DATE: 05.27.2015
TO: ProTrak
FROM: Bill McDow
Transportation Planning

■ **WESTFALL PARK APARTMENTS [TRC Plan Review]**

↻ Initial Review Note ↻

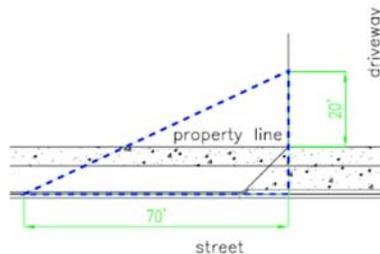
1. The proposed project does not address offsite modifications to the existing road network. Does the project connect Ashes Drive to Fresco Dr.?
